# STAFF REPORT SAN CLEMENTE ZONING ADMINISTRATOR

**SUBJECT:** **Minor Cultural Heritage Permit, 20-083 Lindbom Residence,** a request to allow exterior alterations and add 91 square feet to a historic residence with a City Mills Act agreement.

**LOCATION:** 1815 Calle De Los Alamos

**Figure 2 – Replacement courtyard staircase**

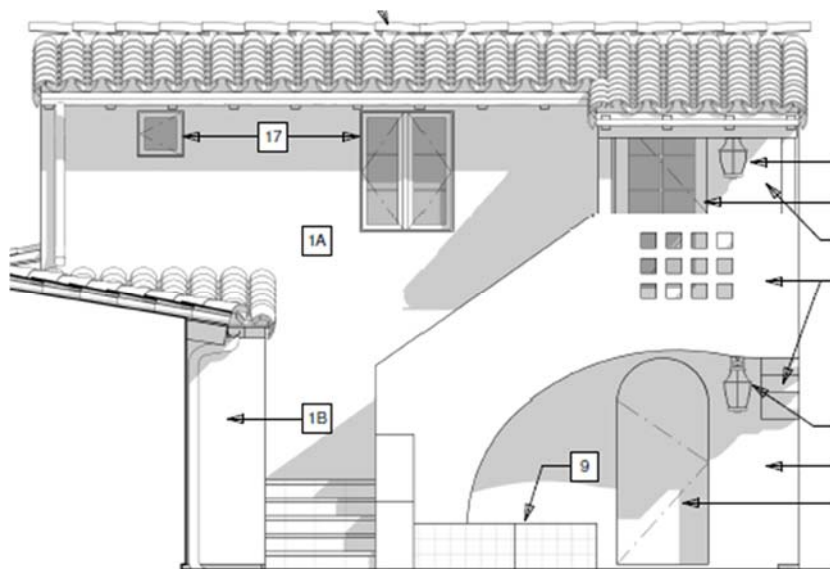
- Replace a non-original staircase used to access a second story studio from the interior courtyard. Mills Act Improvement 14 contract calls for a replacement staircase to have a design, size, scale, and materials that are compatible with the historic structure. Figure 2 below shows the proposed staircase design, modeled after the stairs on the historic resource at 1533 North El Camino Real.

Beginning with the courtyard stair design, we were able to come up with a very nice and more open stair design by lowering the stucco guardrail down, and adding a wood guardrail, while still maintaining enough mass for the arch and corbel detail. This will reduce the massing and visibility of the stair from the courtyard and from Calle de Los Alamos, closer to what we assume was its original design.

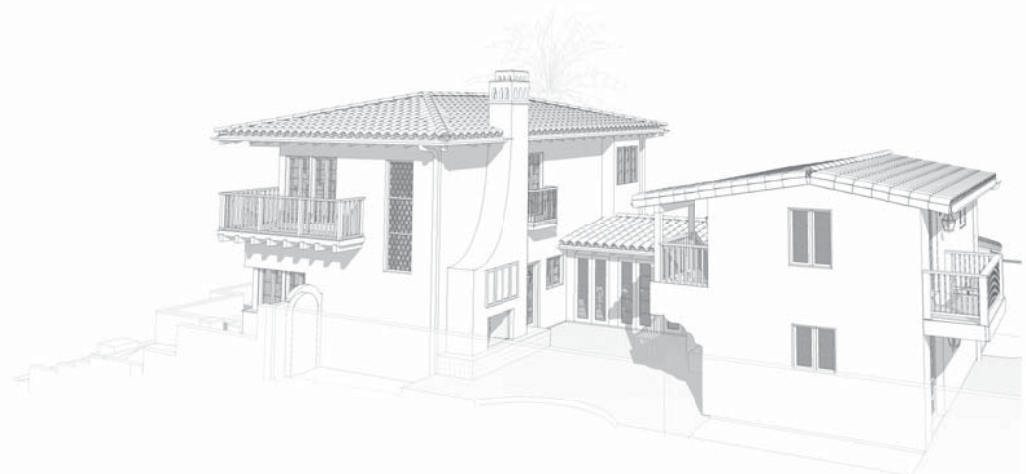
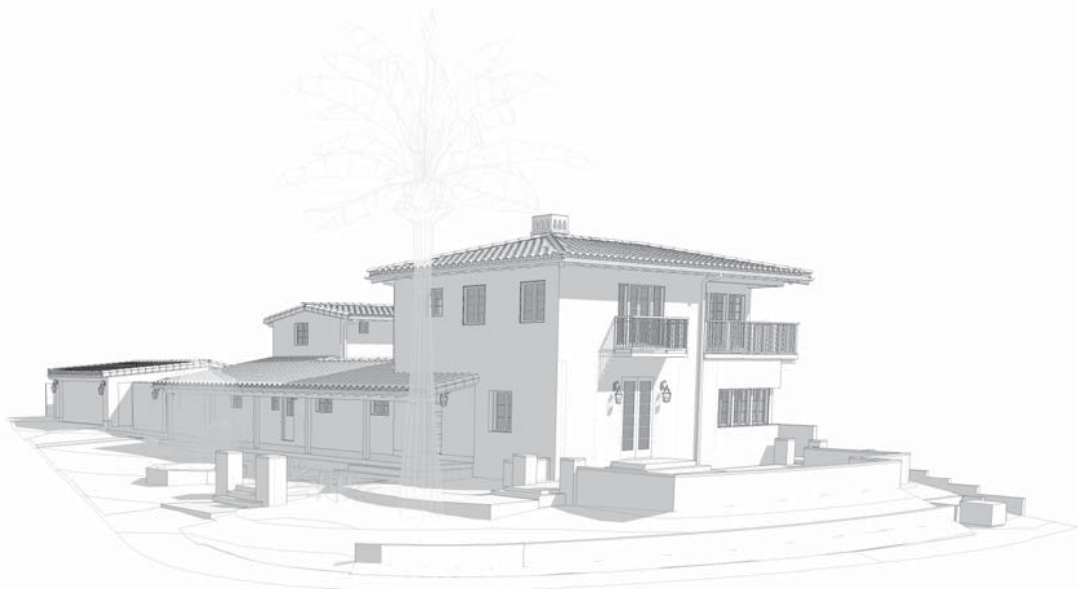
Regarding the rear garden wall and gate design, staff and the Commissioners were not in support of the client's desire to have a keyhole gate expressed on the street side of the wall, but were in favor of that element being expressed on the interior side with a simpler gate design as viewed from the street. In addition, staff recommended that the existing open wood beams and the proposed roof tiles be removed from the design so that the wall would appear as a garden wall, and not an extension of the building. We have revised the design to be a simple arch-top gate and recessed stucco opening on the street side, and a recessed keyhole opening on the interior backyard side. To add interest to the design, we lowered the existing wall height on either side of the gate with a swooping arch top at the existing wall height above the gate to provide enough thickness above the arch. In order to keep the wall height above the gate at the existing wall height, we added a step with a landing on the interior side of the wall.

Regarding the courtyard fireplace and chimney, the Commissioners gave us the direction to first look at relocating the fireplace away from the building. If it was not possible to relocate the fireplace, we were asked to look at the chimney design, reduce the mass and if it must be visible, tie the new and existing chimneys together with a consistent design and massing. We have looked at alternate fireplace locations during the design process, and again after the Commissioner's request, and based on the client's needs this is really the only location that works. There was a recommendation to locate the fireplace as a stand-alone element at the neighbor's side facing the courtyard. This location does not meet the client's needs because the neighbor to the South has a second story deck that has a view into the courtyard, and we

are proposing planter and tree along the neighbor's side to obscure the view and provide some privacy. One of the original design decisions for locating the fireplace where it is, was that it is very protected from the elements with the prevailing weather coming in off the ocean and the proposed fireplace is behind the 2-story wall. Another recommendation was to stop the chimney part way up the wall, but we feel that although it is possible to vent the fireplace using a gas appliance, this was not an architecturally acceptable solution because everybody expects a fireplace to have a chimney that extends above the roof eave or wall it is attached to. Finally, we concluded that we would work on the chimney design to minimize the mass visible from the street, and tie the new and existing chimney style and size to a cohesive design. We engaged a roofing contractor to get up on the roof to measure and photograph the existing chimney which we hadn't done up to this time, and we found that the existing wood burning fireplace chimney was larger than we had drawn. We then contacted the fireplace distributor to determine the minimum size for that chimney to replace what was there with a more traditional Spanish Colonial Revival design. Based on the minimum size for the existing chimney, looking at the proportions of this 2-story chimney and working with Staff, we lowered the chimney height, and replaced the more ornate metal shroud with a simple 30" square stucco chimney with 3 arched openings on each face and a stucco band below the openings. The proposed chimney plan dimensions are about 4" less in either direction than we had previously drawn. In fine tuning the design, we also determined that the depth of the firebox was about 6" deeper than we had drawn which is why the chimney location is further into the courtyard as was previously shown, but not larger.
